Addendum Report No. 2 to Committee Report: Application No: 23/01102/FULMAJ	
Committee	Date:
Planning Applications Sub Committee	9 April 2024
Subject: Hill House, 1 Little New Street, London, EC4A 3JR	Public
Demolition of existing building above ground with retention of existing basement and piles/ foundations and erection of a mixed use office building comprising two basement levels, lower ground, upper ground and upper ground mezzanine plus 18 upper storeys for the provision of office space (Use Class E), gym/auditorium (Use Class E), flexible office, café/retail (Use Class E), reprovision of existing library (Use Class F1), flexible library/office (Use Class F1/E) and restaurant (Use Class E), discontinuance of the City Walkway (Little New Street To Wine Office Court), enhanced and enlarged public realm, hard and soft landscaping, highway works, and associated enabling works.

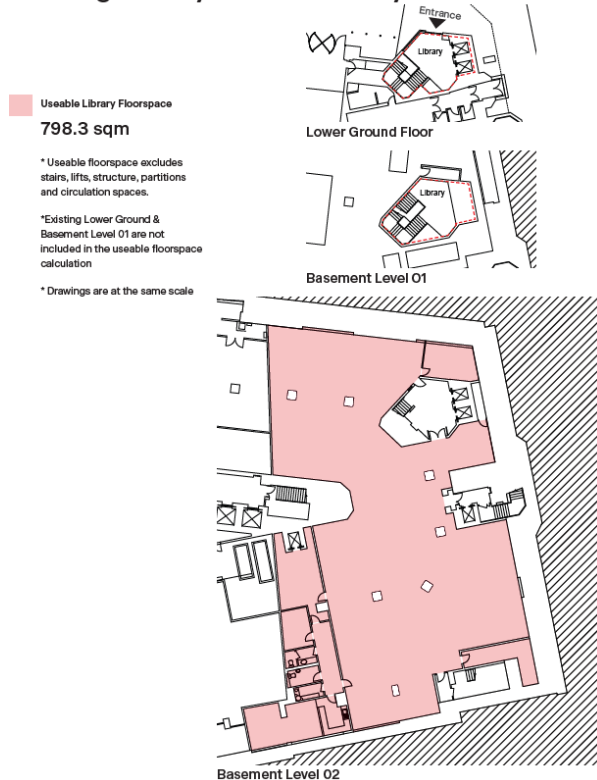
- In the Summary page, the Application Sheet, and at paragraphs 24, 95, 115, 119, 782, there are some minor discrepancies for floorspace figures therefore these have been included in the table below:

3. The proposed development will provide a new library at ground floor and mezzanine level. The proposed usable internal area of the library will be 800 sqm Net Internal Area (NIA), which is slightly higher than the existing library. The new library would benefit from a new double height entrance directly from the street and double height space with natural light and direct access to external public realm, which it currently does not benefit from. Therefore the replacement floorspace would be of a better standard than existing. In addition, the library also has the potential to benefit from the sublease of up to additional 467.5 sqm floorspace for affordable/flexible workspace.

4. The new library will have a Gross Internal Area (GIA) of 843.3 (excluding plant) which is slightly lower than the existing library. This is because the new library will be provided at grade, resulting in a less convoluted journey to the library, and thus less circulation area. The existing Library is contained at basement level 02, with access to the library via two lifts and a stair lobby from ground, basement 1 and basement 2 levels. The existing library comprises a GIA of 1,016.4 sqm with total of 218sqm of this area as circulation space comprising the stairs/ lifts, providing access to basement level 02 (useable area for existing and proposed library shown in image below in pink). This circulation area does not form part of the usable area of the library, and results in a convoluted journey to the basement 2 level. Accordingly, the usable internal area of the existing library is considered to be 798.3 sqm (NIA).
